Product Change Notification

Change Notification #:	**915594-00**
Change Title:	**Select Intel® Ethernet Network Adapter OCP3.0 E810-XXVDA4**
Change Detail:	**Replacing E810-DA4 4X10/25G OCP Ethernet Bracket With Insulated Faceplate**
Date of Publication:	**March 23, 2026**

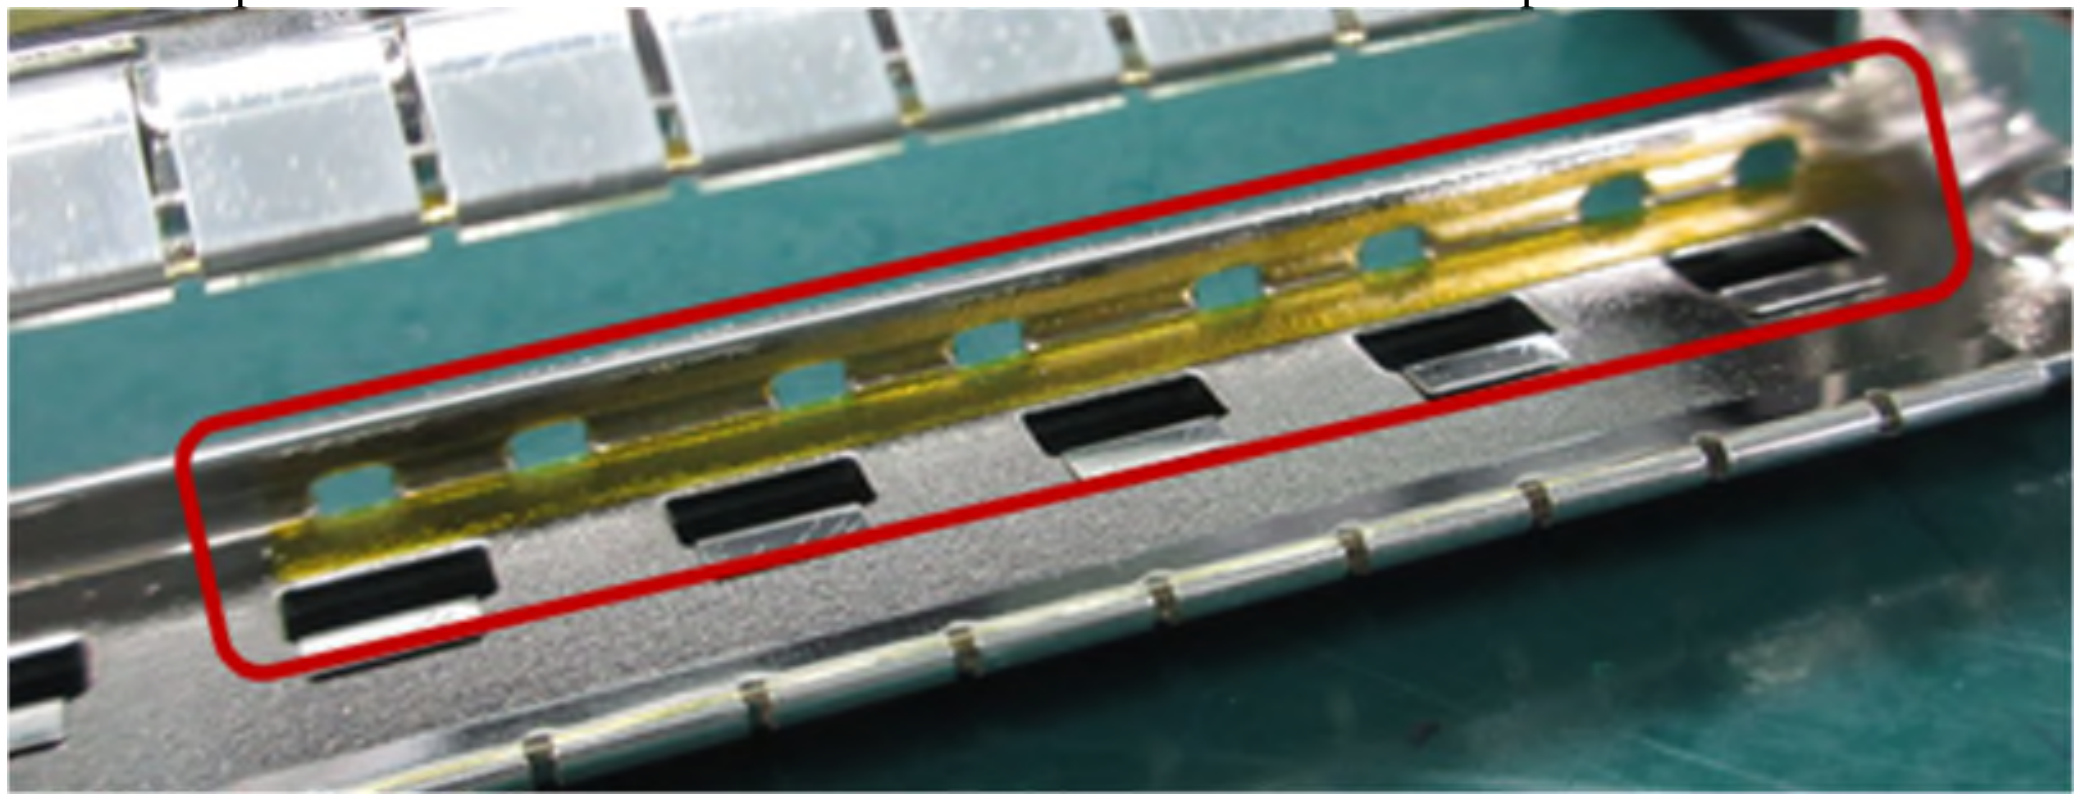
A 0.05mm Kapton insulating film (rated to 260°C) is applied to the inner surface of the J96050-00X/K35854-00X bracket to prevent electrical contact between the LED and bracket faceplate.
